City of Poughkeepsie
Planning Board
Meeting Agenda

Virtual Meeting
Meeting Registration
Link: https://attendee.gotowebinar.com/register/8382001969761123853
Tuesday, December 21, 2021
7:00 PM

CITY OF POUGHKEEPSIE
PLANNING BOARD MINUTES
NOVEMBER 16, 2021

Sheet No. SG-1

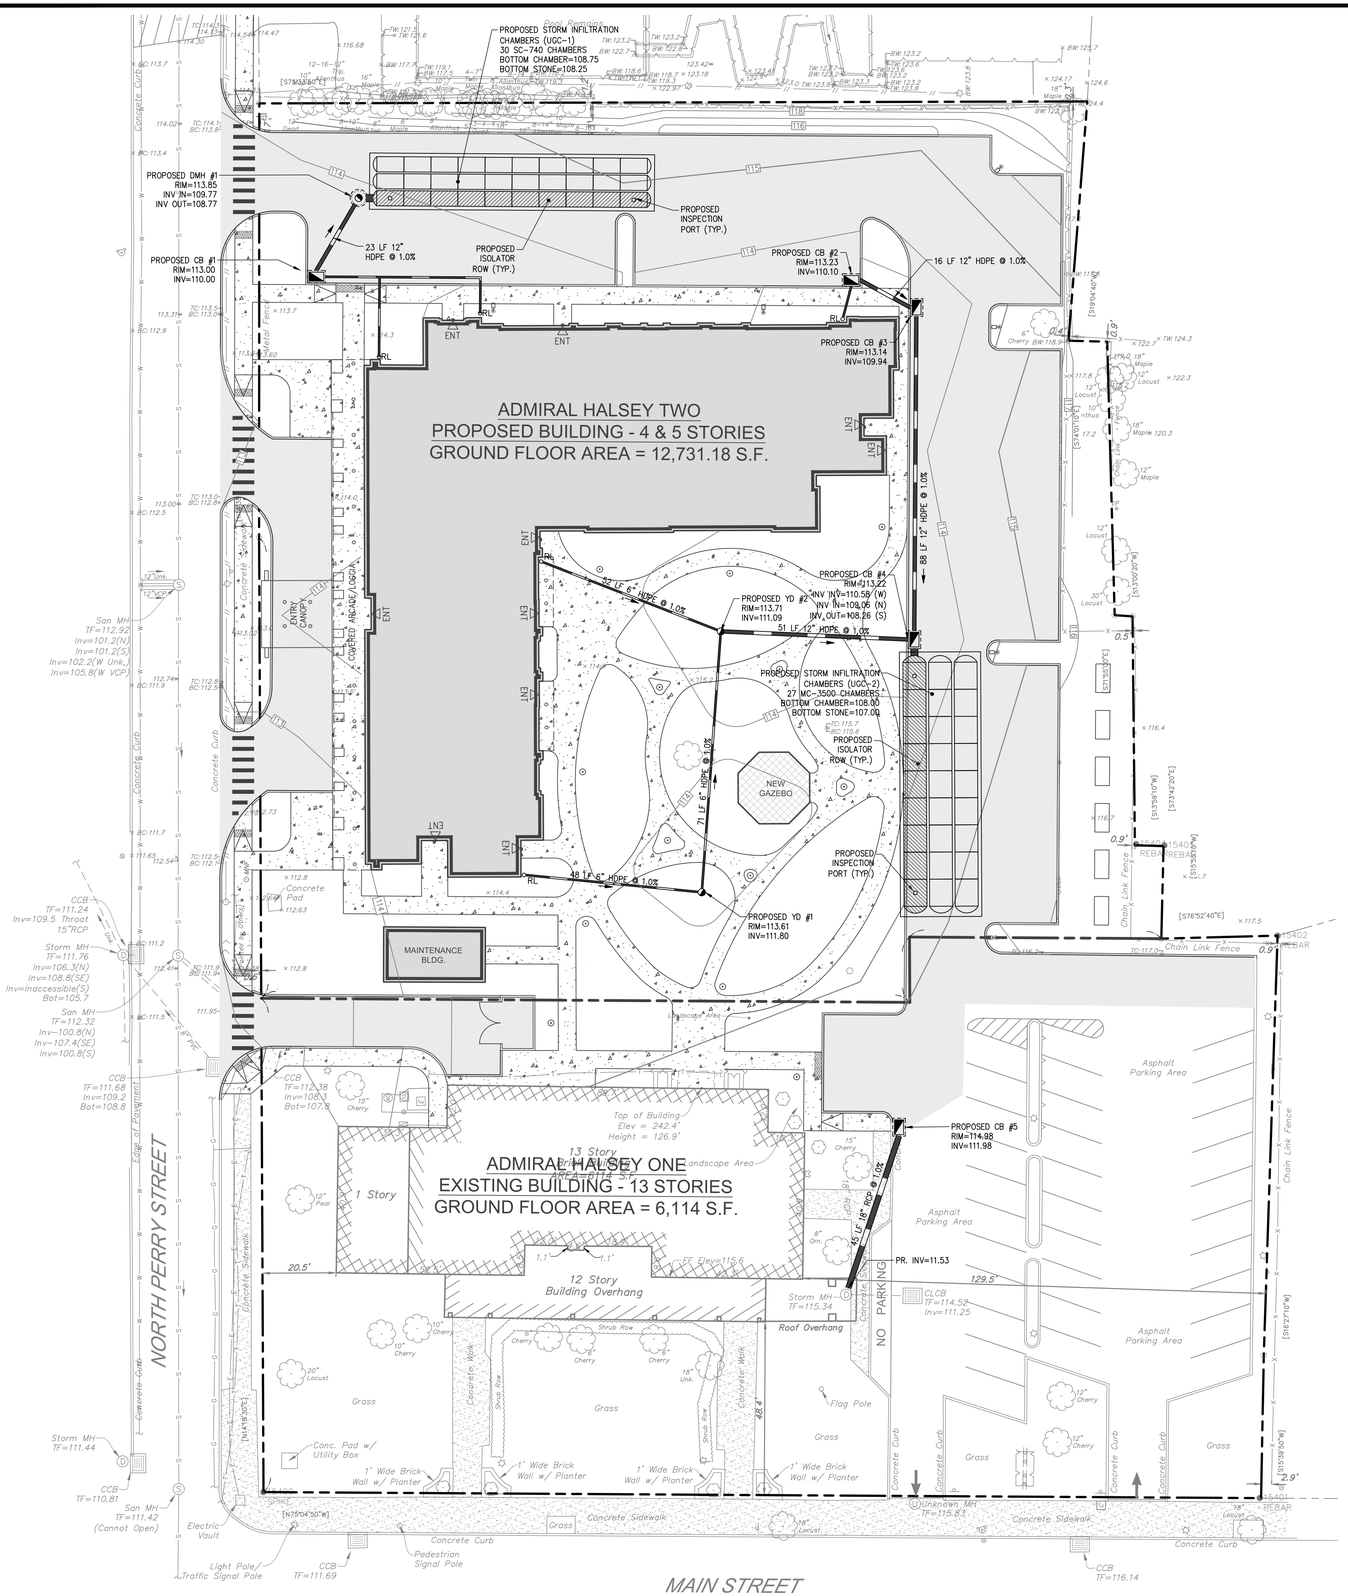
5. Sheet SG-1: provide sufficient cover at all proposed drainage structures.
6. Per the NYS Stormwater Management Design Manual, January 2015, dry wells should receive rooftop runoff only. It appears the proposed dry wells are intended to receive parking lot runoff as well.

Sheet No. UT-1

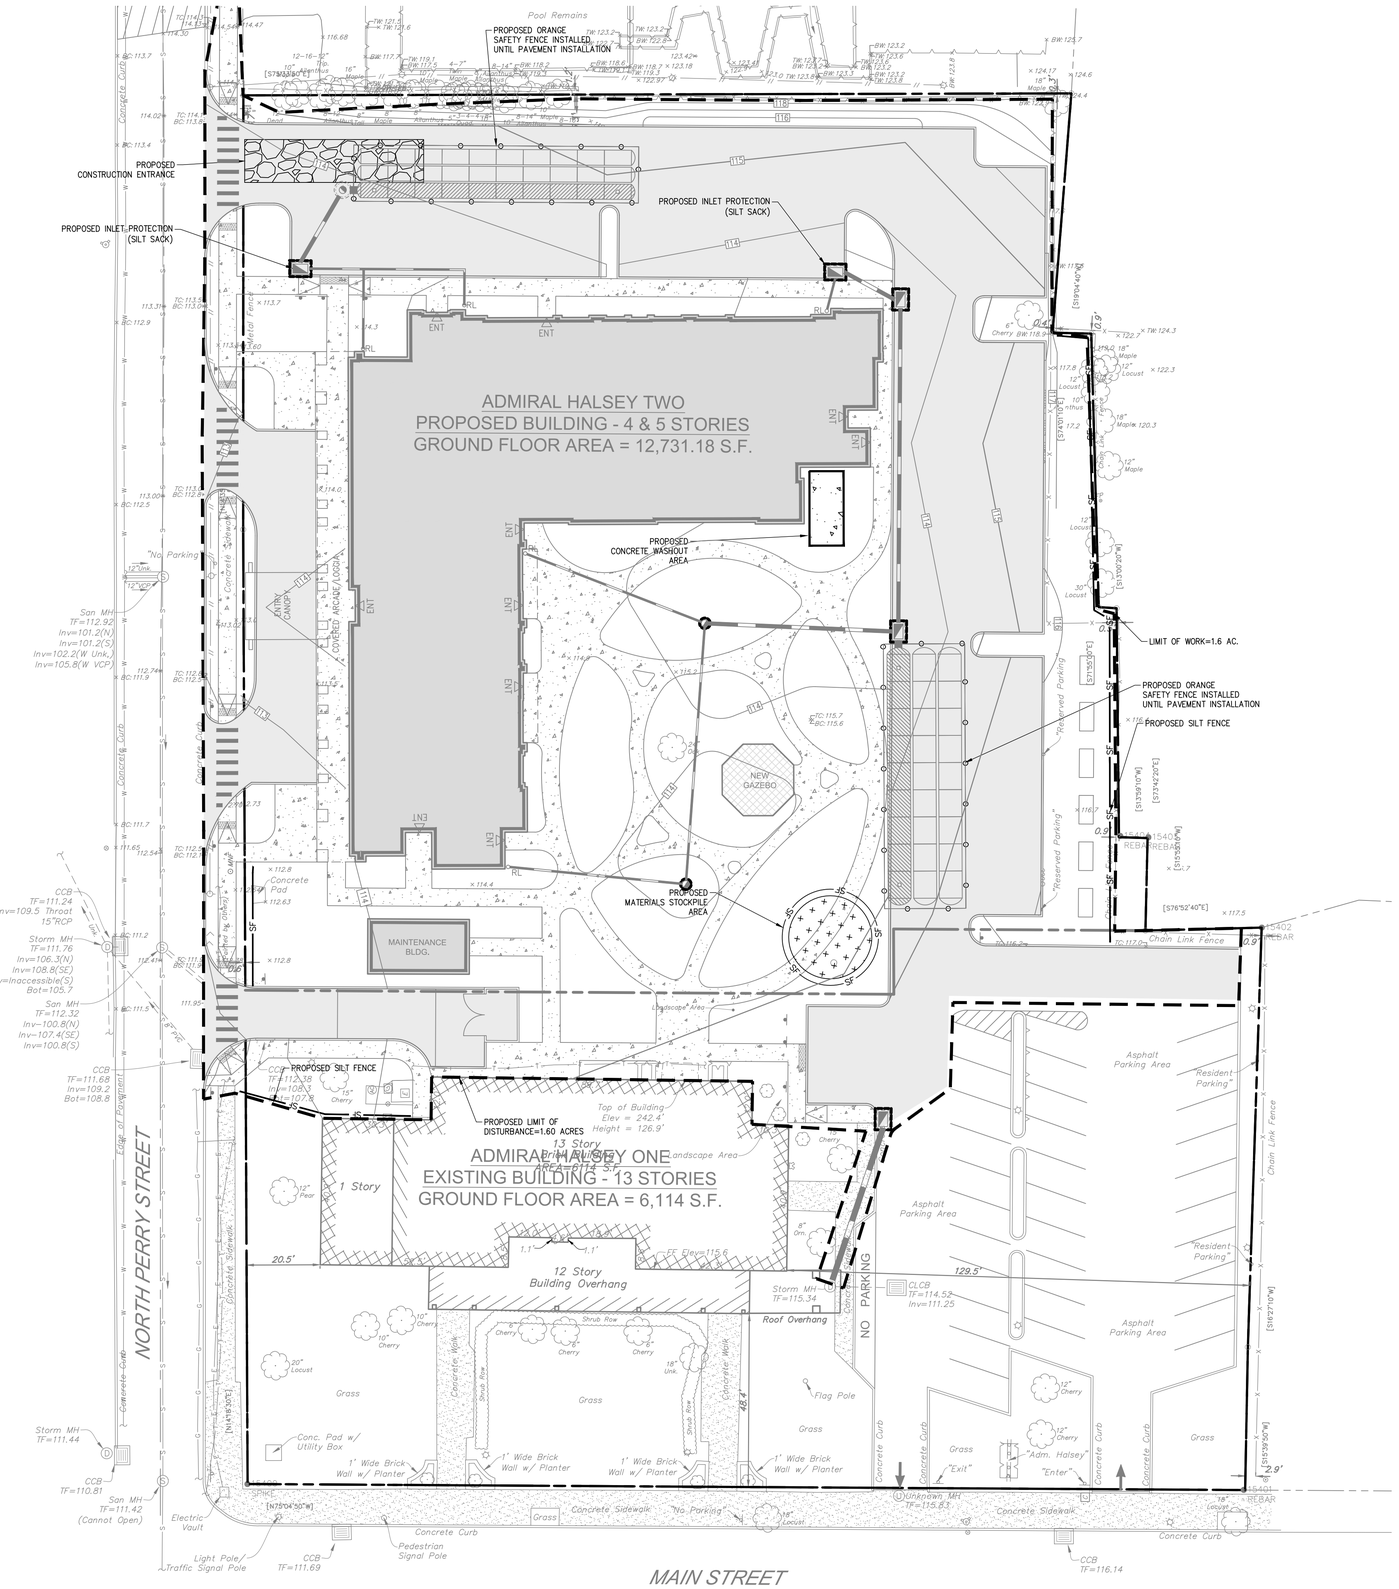
2. Sheet UT-1: Show size of existing sewer mains and ensure adequate invert at point of service lateral connection.
3. Engineering Report, Section 3.2: verify with City Engineering that the existing wastewater plant and the collection lines in the vicinity of the project site have sufficient capacity to serve the additional wastewater generation resulting from the proposed project.
4. Engineering Report, Section 3.3: reference made to 311 Main Street, which is not part of the proposed project- revise accordingly.
5. Reference made to 311 Catharine Street addition, which is believed to be a reference to the seven-story addition to 331 Main Street located along Catharine Street adjacent to #14. Revise references to this proposed addition in the report for clarity.
